BCA Design Assessment Report

Stage 1 - Warnervale Primary School

Project: Stage 1 - Warnervale Primary School  
 Document Type: BCA Design Assessment Report  
 Report Number: P218\_016-4 (BCA) NH

Figure 2.1 – Site plan

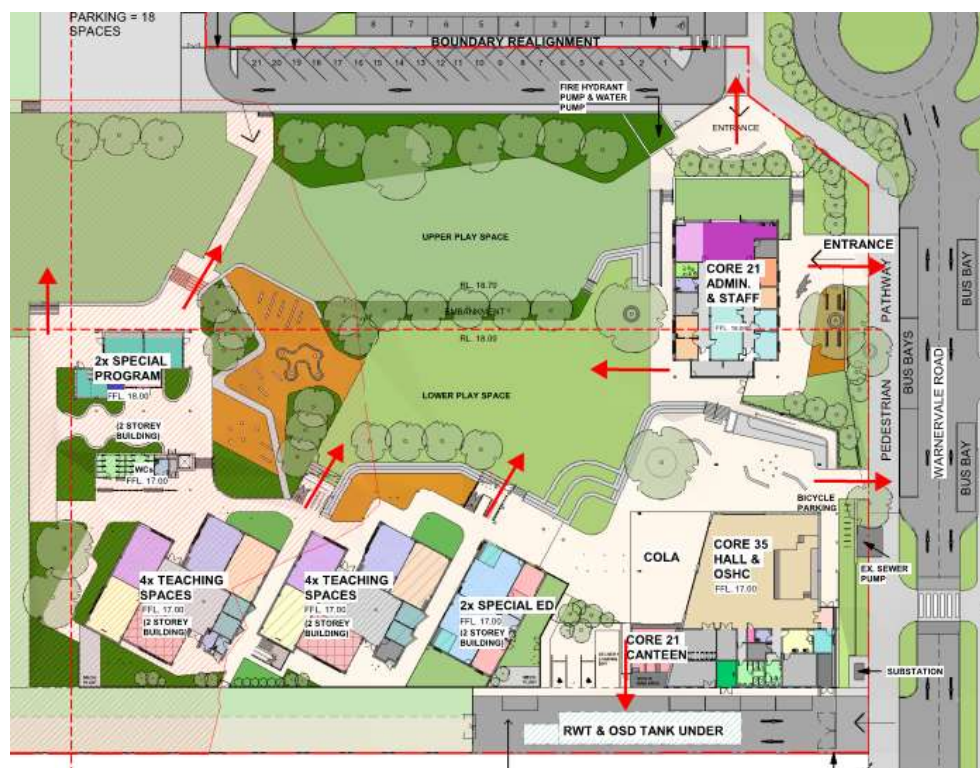
- (i) The Special Ed / Teaching Spaces and Special Program building have been treated as being of Type B construction;
- (ii) The Core 21 Admin & Staff, Core 35 Hall & OSHC and Core 21 Canteen have been treated as being of Type C construction;
- (iii) The buildings comprising 2 storeys have not been treated as containing fire isolated stairways;
- (iv) Exits have been treated as coinciding with one being open to the sky (unroofed);
- (v) The egress strategy adopted within this assessment is highlighted in figure 2.1 below;

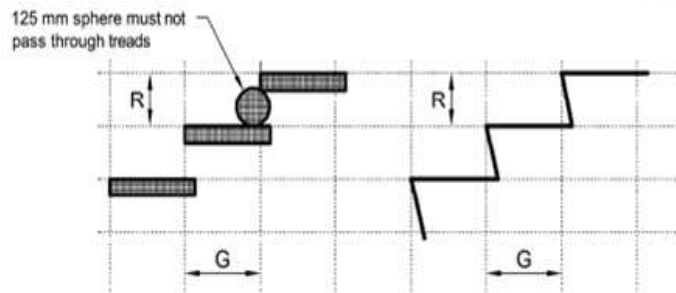
D2.8 The space below a required non-fire isolated stairway (including an external stairway) must not be enclosed to form a cupboard or other enclosed space unless –

- (i) The enclosing walls / ceilings are to achieve an FRL of not less than 60/60/60;
- (ii) The doorway opening into the store room is required to be a self-closing fire door achieving an FRL of --/60/30.
